APPENDIX D: AGENCY COMMENTS ON RESPONSE TO SUBMISSIONS

From: Malcolm Hughes <Malcolm.Hughes@waternsw.com.au>
Sent: Friday, 11 November 2016 9:04 AM
To: Rose-Anne Hawkeswood
Cc: Paul Freeman; Girja Sharma; Nicole Wallwood
Subject: RE: Springvale Mine Extension Project - SSD 5594 MOD 1 - RTS

Springvale Colliery Extension Project Modification 1 (SSD 5594 MOD 1) Comment on the Response to Submissions

Springvale Colliery Extension Project Modification 1 (SSD 5594 MOD 1) Comment on the Response to Submissions Detailed comments – DPI Water

Figure 1. Extracted Figure 2.1 from Jacobs' report

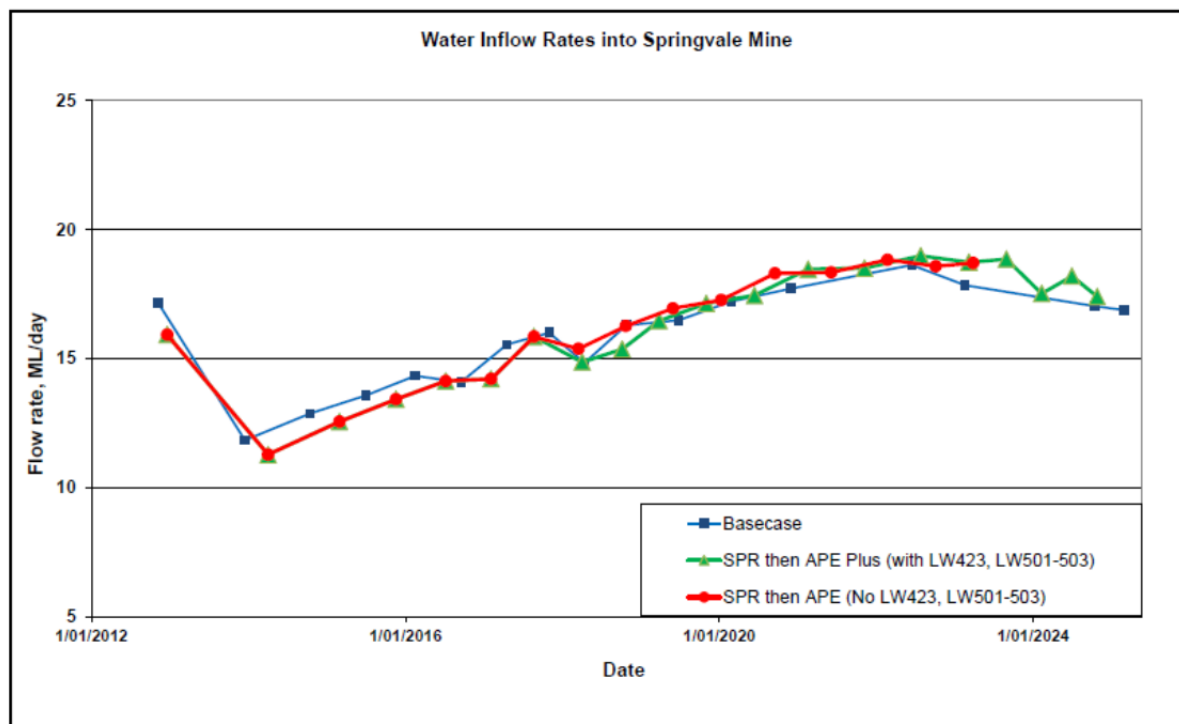
The Proponent has re-run their COSFLOW NGM for the correct mine layout and generated the necessary outputs. The outputted results now properly reflect the approved mine layout, irrespective of any business reason to exclude them (see Appendix C for an enhanced discussion). The previous work was erroneous and poorly explained. The revised outputs are shown in Figure 1 and are very similar to the original. Following this, the Proponent's analysis of the results depicted in Figure 1 is presented.

- The mine inflow results presented for the 'SPR then APE Plus' simulation, which included all approved longwalls at Springvale Mine under SSD5594, are consistent with the original 'SPR then APE' case (Adhikary and Wilkins, 2015) and the CSIRO (2013) predictions (Adhikary and Wilkins, 2013) which assessed the entire mine footprint. Maximum mine inflows for the three simulations are provided below:
 - The maximum mine inflows for the 'Basecase' (Adhikary and Wilkins, 2013) is 18.6 ML/day in 2022
 - The maximum mine inflows for the 'SPR then APE' case (Adhikary and Wilkins, 2015) is 18.8 ML/day in 2022
 - The maximum mine inflows for the 'SPR then APE Plus' case (Adhikary, 2016) is 19.0 ML/day in 2022.
- The Springvale Mine Extension Project EIS (Section 10.2.3.1) notes the maximum mine inflow for the whole mine plan, the 'Basecase', as approved, as 19 ML/day in Year 2022.

Given the above, the baseflow predictions, with respect to modelled surface water reaches, and modelled mine inflows in the 'SPR then APE Plus' simulation, are consistent with Adhikary and Wilkins (2015) report, and, as presented in Adhikary and Wilkins (2015), are consistent with Adhikary and Wilkins (2013). The impacts and environmental consequences for the proposed modification area are therefore expected to be consistent, as discussed in the SEE, with the impacts presented in the SVMPE EIS and approved in SSD5594.

DPI Water accepts this analysis.
